CONCEPT DEVELOPMENT PLAN BOONE COUNTY PLANNING COMMISSION

2. Name of Project TownePlace Suites/ SpringHill Suites

Request of **Viox & Viox (applicant)** for **Shihasi Turfway, LLP, Shihasi Blue Ash, LLP, and Shihasi Corporation (owners)** for two changes in approved Concept Development Plan in a Commercial Two/Planned Development/Houston-Donaldson Study Corridor Overlay (C-2/PD/HDO) zone for a 6.237 acre site including the tracts at 7484 and 7492 Turfway Road, and the 0.472 acre vacant tract in between the properties at 7484 and 7492 Turfway Road, Florence, Kentucky. The request is for modifications to two Concept Development Plans to allow an additional hotel and increase the building intensity for the existing hotel at 7492 Turfway Road by reducing the lot size, and modifying previous conditions of approval.

FRONT / EAST ELEVATION

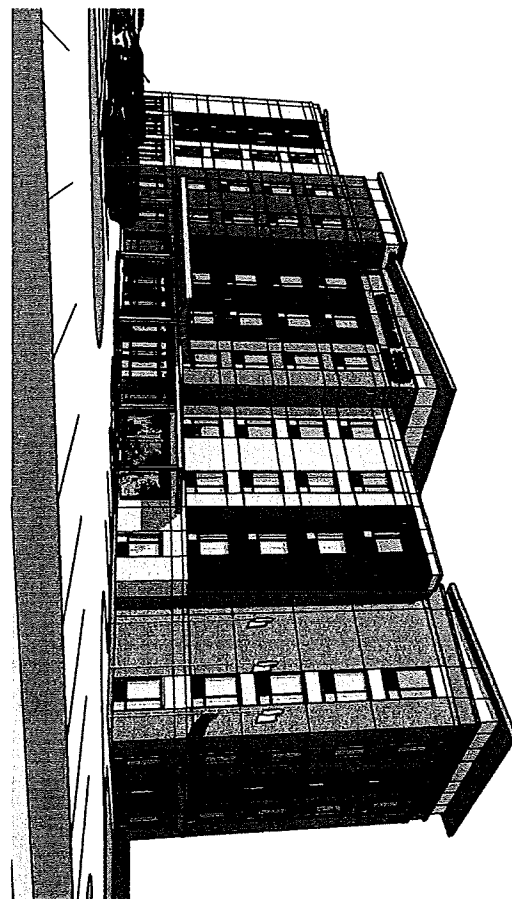
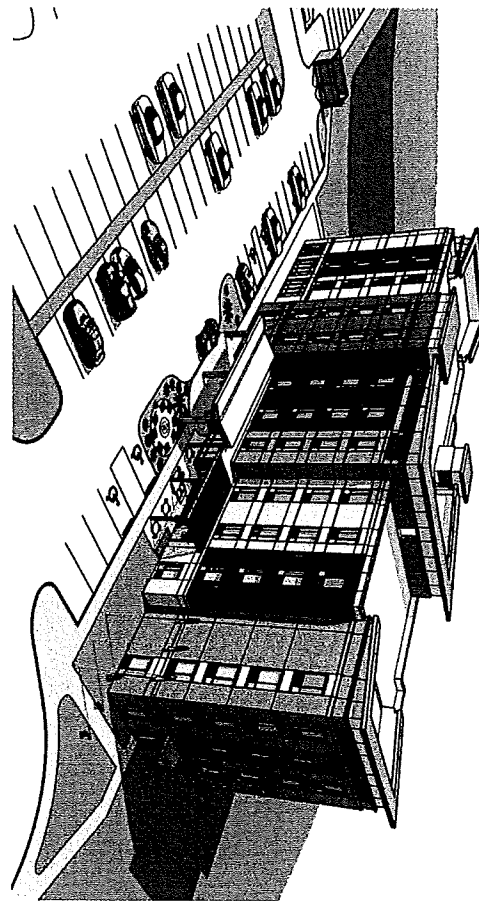
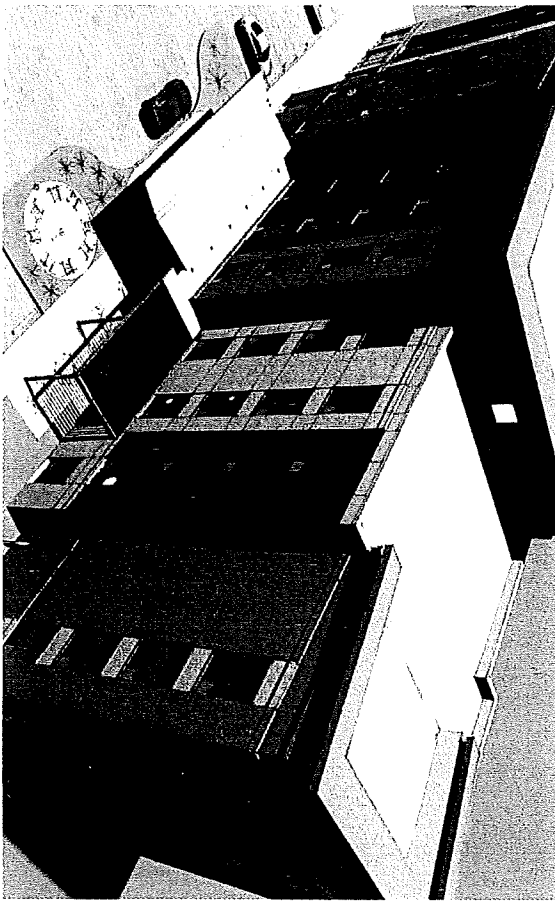
- Submit building elevation drawings of the sides and rear of the building.
 - The front elevation drawing shows that "LED continuous strip lighting" is being proposed under the roof elements. Please provide pictures and address the color of the lighting.

- Confirm no building mechanicals will be visible on the roof.
 - Address the height and materials of the retaining wall (rear patio area).
 - The Concept Plan and elevations are not consistent. The Concept Plan shows the front facade (northwest side) will have a seating area behind a wall or fence.
